Our Ref: 25_32001_C

29 July 2025

Notice of Intention to Grant Consent to discharge surface water run-off into watercourse: Surface water discharge from new extension at Cordon Villa, 24 Station Road, Gedney Hill, PE12 0NP

Figure 2: Site plan and drainage route as shown in drawing number AJA/1286/25/SWD (Austin John Architectural, 13/06/2025) submitted by applicant.

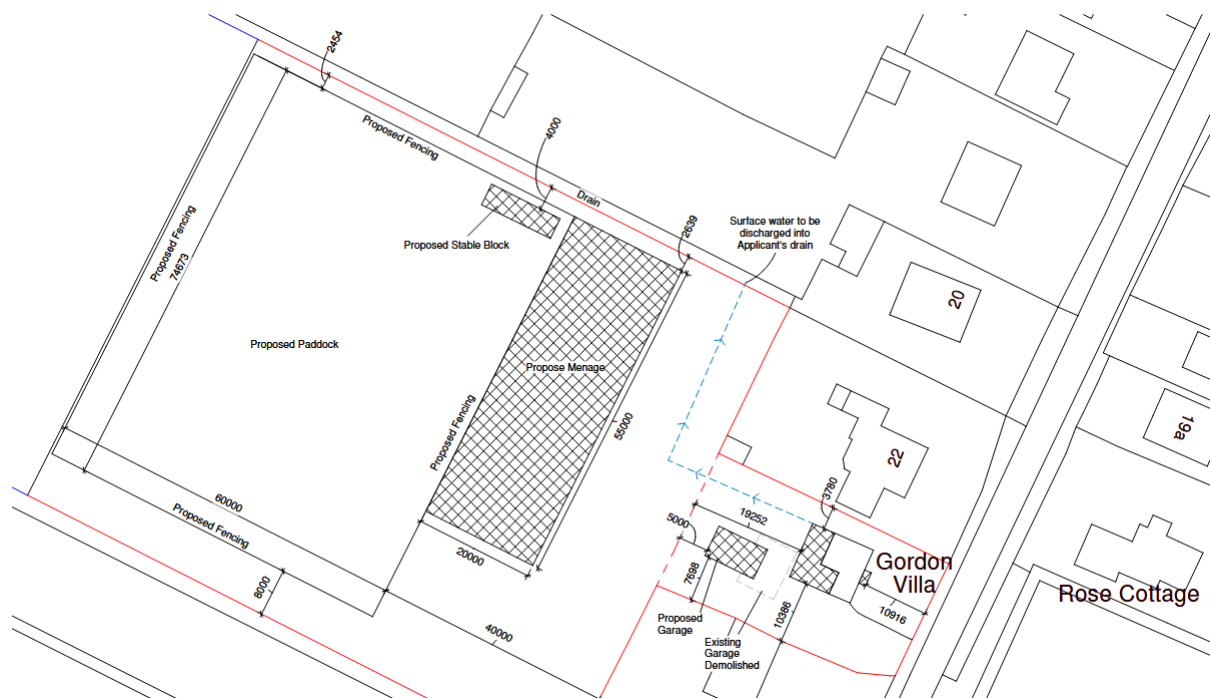
- S1 Discharge rate: The discharge of surface water run-off from this site will be unrestricted.
- S2 Outfall details: Consent is for the installation of a 100mm diameter outfall pipe at invert level above the silt level of the watercourse with associated headwall to be constructed in the riparian watercourse at the approximate location 533589, 310889 as shown in drawing number AJA/1286/25/SWD (Austin John Architectural, 13/06/2025) submitted with your application, and below in figure 2.

- S3 Headwall: Where constructing a new outfall this should enter the watercourse through a suitably-sized pre-cast concrete recessed headwall unit. The headwall and pipe should be installed so that it is flush with the batter of the watercourse with no part protruding beyond the existing bank profile at any point. Alternatively, a bespoke headwall design may be approved in writing by the Board.

- S4 Revetment: You should ensure that the outfall from this drainage system has suitable erosion protection (stone revetment) below the discharge pipe, to prevent any scouring of the bank of the watercourse. All erosion protection must be dug into the bank and bed so that no item protrudes beyond the existing batter and bed profile at any point. All material which is excavated as part of the headwall installation is to be removed from the watercourse, with the area around the new headwall and erosion protection restored to its previous condition as soon as possible.
